**DOCUMENT 00 90 10**  
**ADDENDUM No. 1**

- A. The Construction Contract is known as:  
SA009 – CIP – 12TH ST/CENTURY DR – PHASE 1
- B. Date of this Addendum: 2/10/2026

SA009 – CIP – 12TH ST/CENTURY DR – PHASE 1

PP1

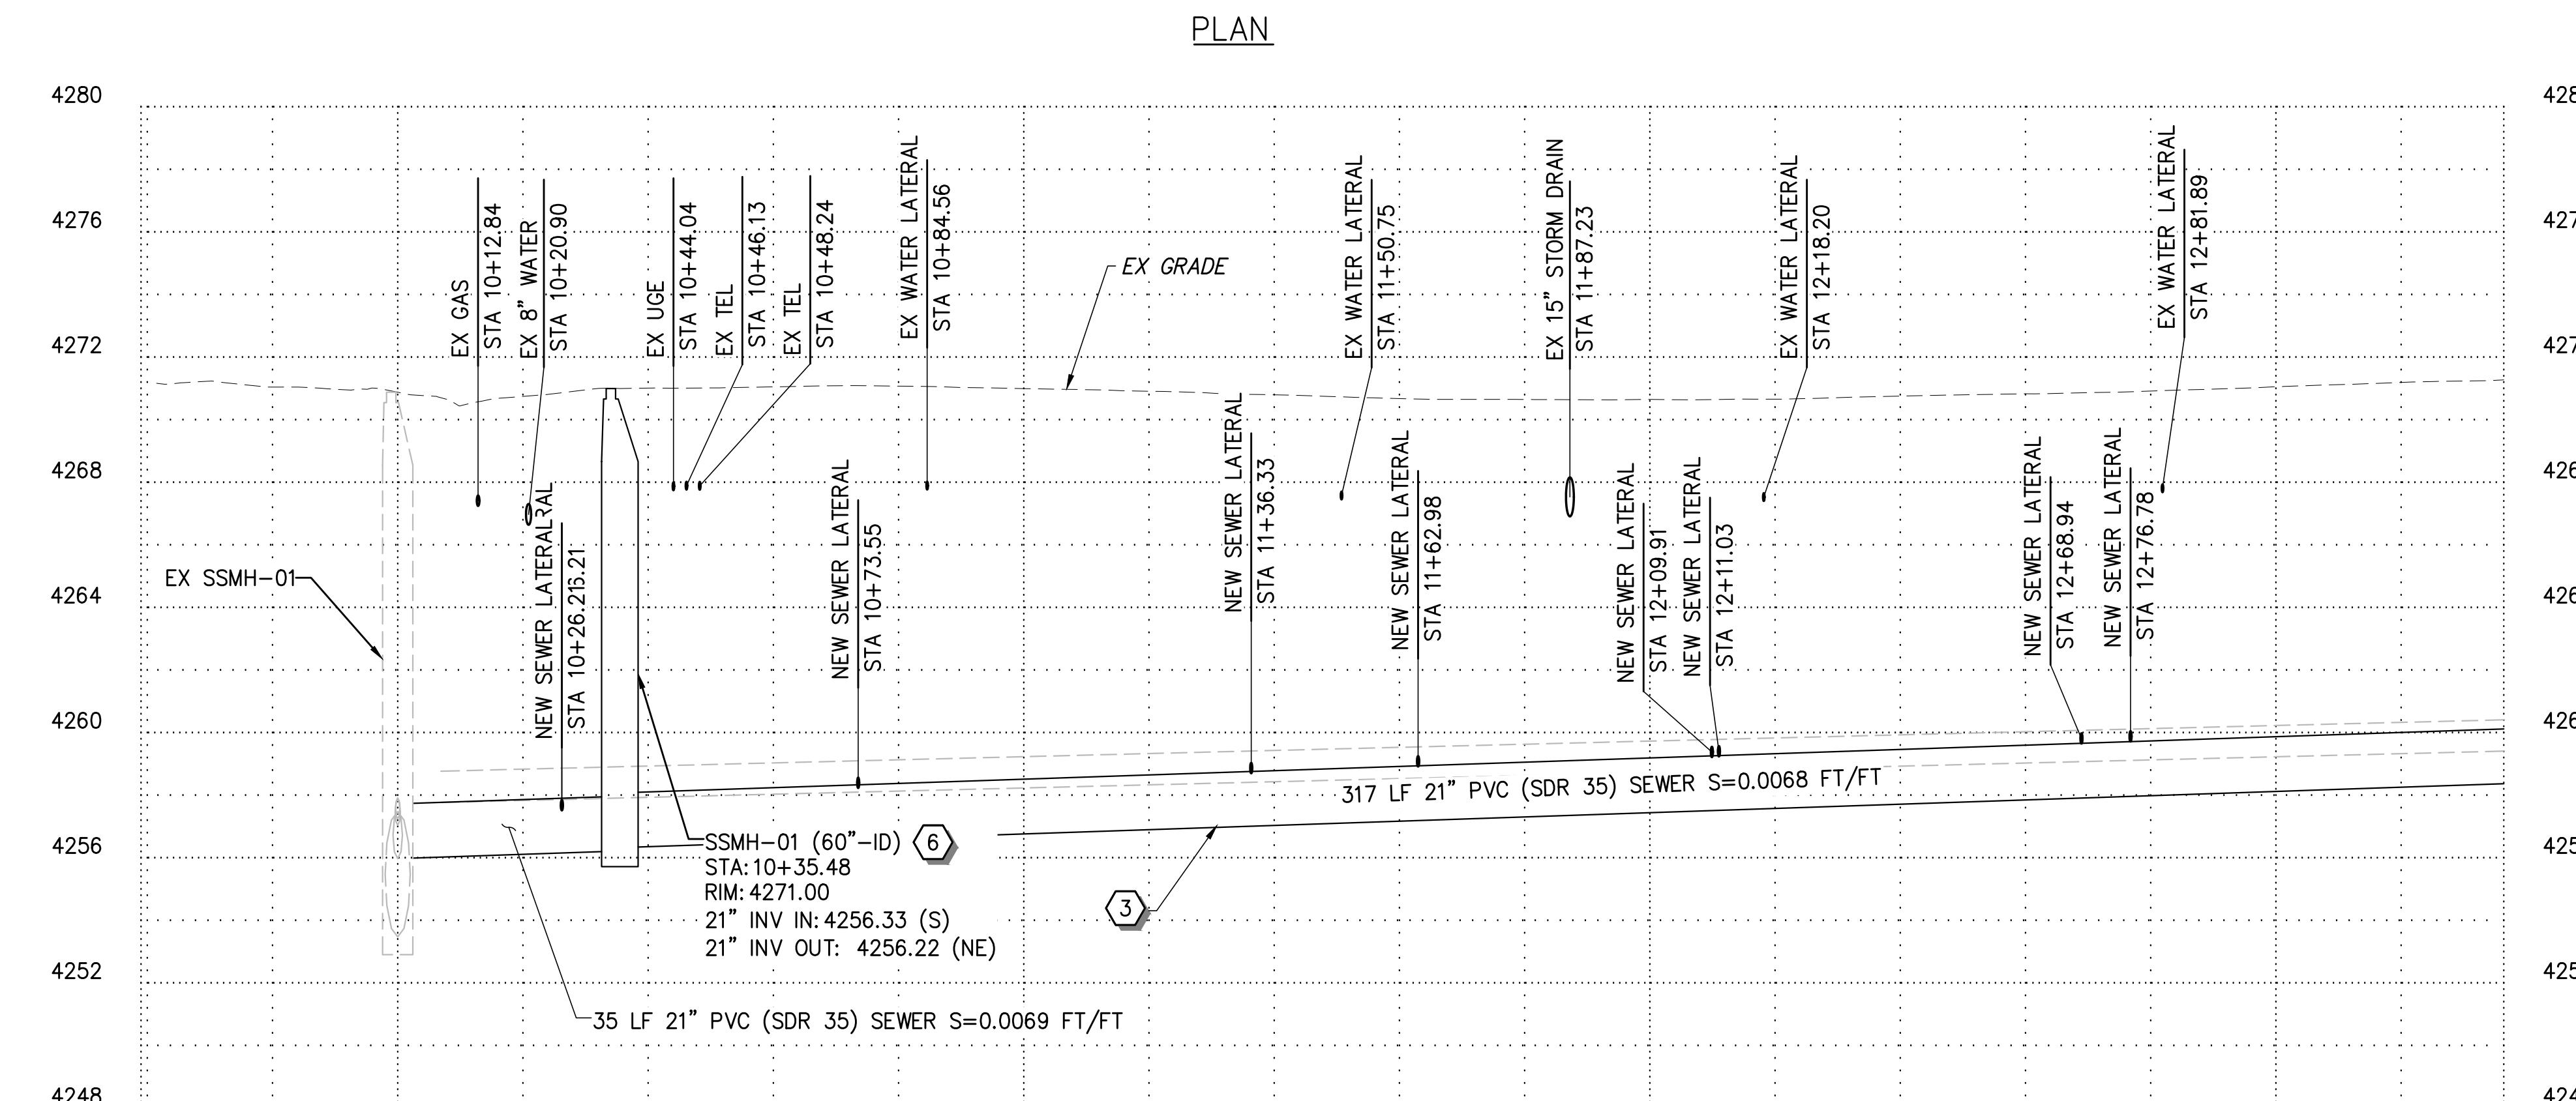
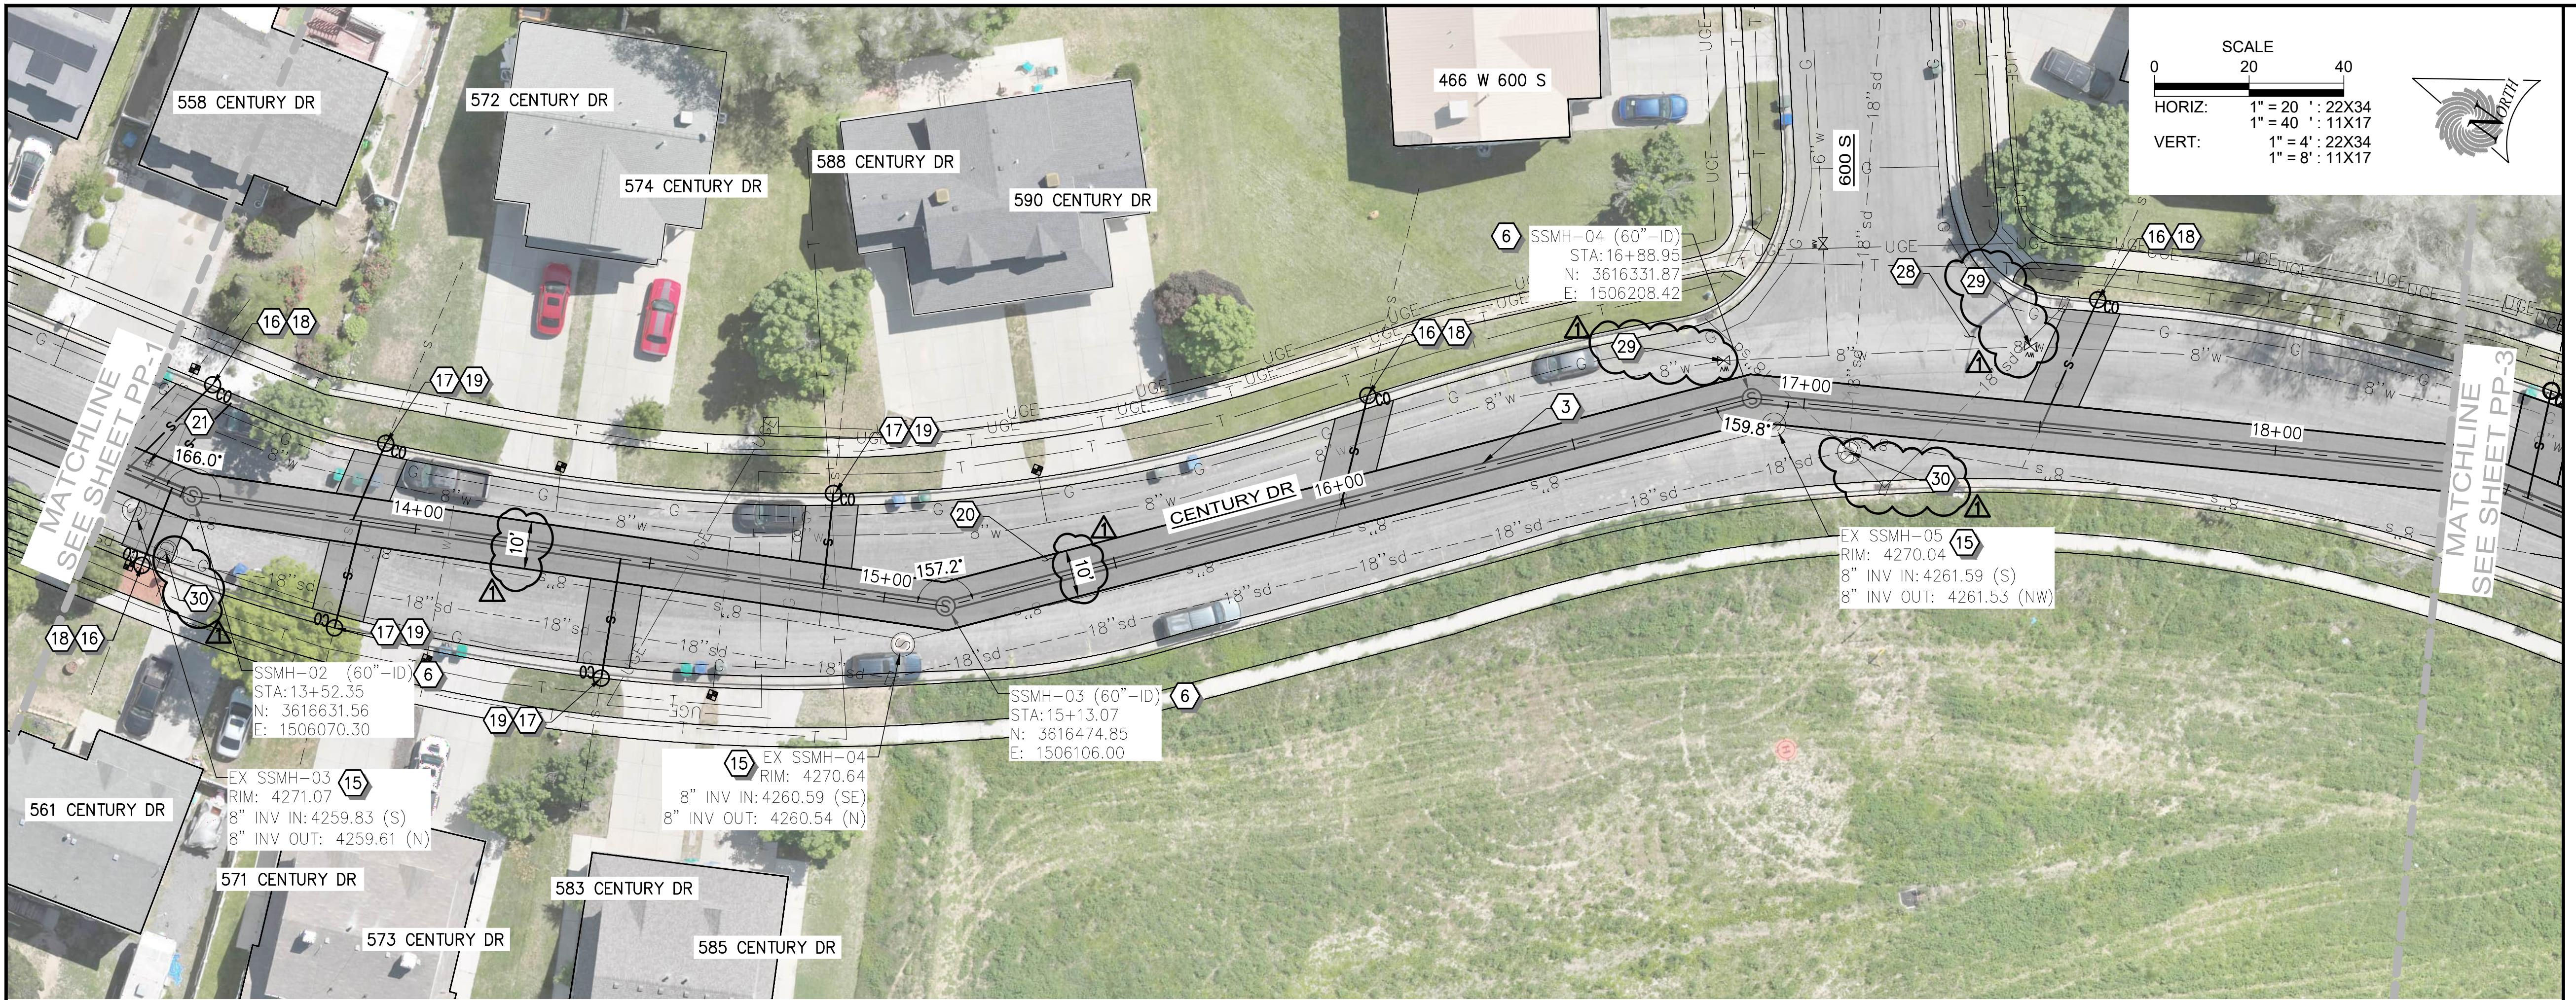
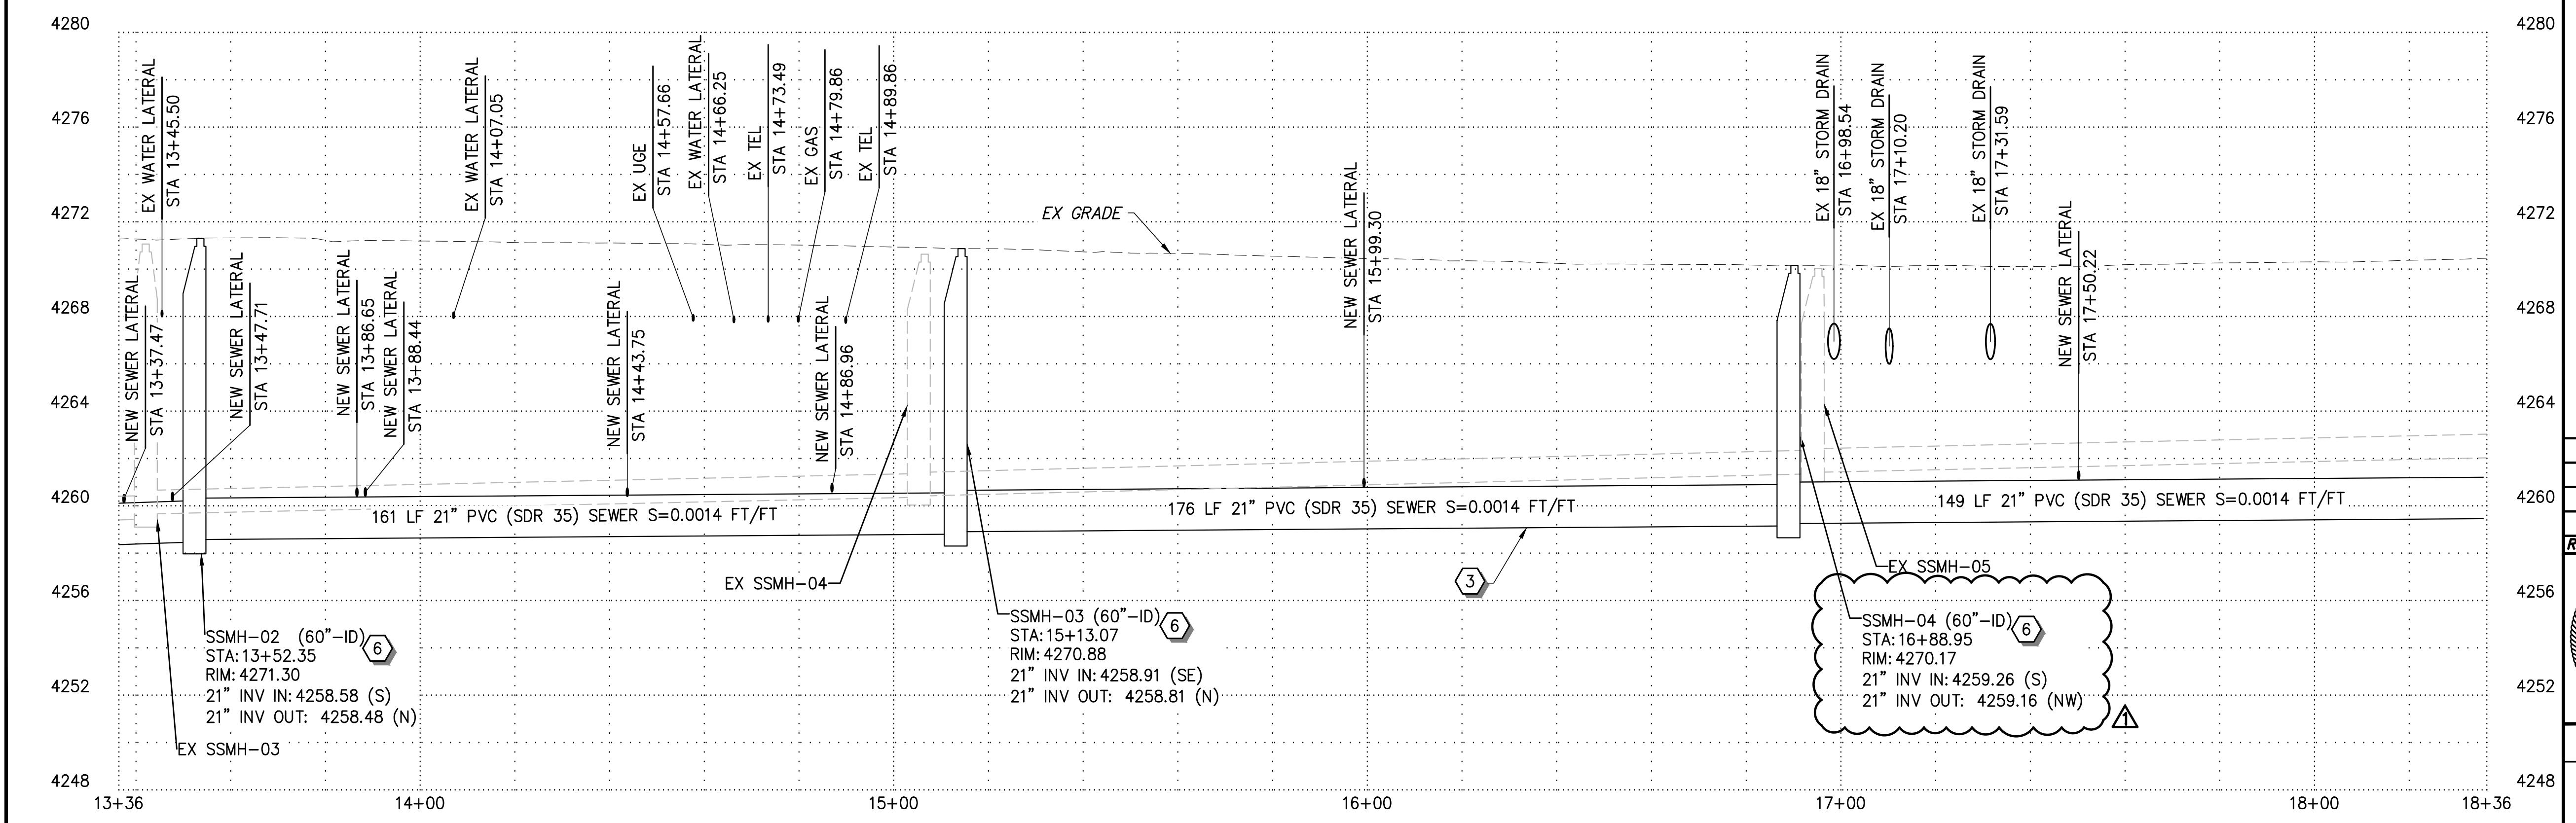
- A. Sheets PP1 to PP7 and C1: Added three new construction notes with accompanying symbols at appropriate locations. Changed construction note 20 from 4" to 6".
- B. Sheet PP1 to PP7: Adjusted width of the asphalt trench and dimension label.
- C. Sheet PP1 and PP3: Added note to applicable cleanouts to remove and restore concrete.
